DESIGN IMPROVEMENT ON BLOWER CONNECTION

Starting February 21st, 2013, Giant Factories Inc. has improved the design of its connection to the blower unit on model **UG75-76MEPV-N2U** and **UG75-68MEPV-N2U**. The connection between the wiring harness of the water heater and the blower unit is now detached from the top pan.

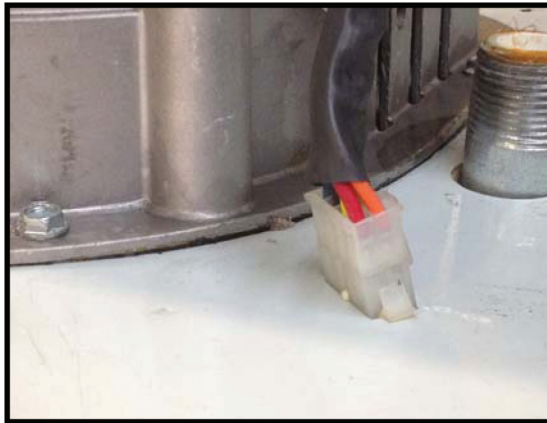
By doing so, we are avoiding a potential issue where water that could accumulate on the top pan during installation, service or operation of the water heater could infiltrate the connector that was snapped to the top pan and create a short circuit.
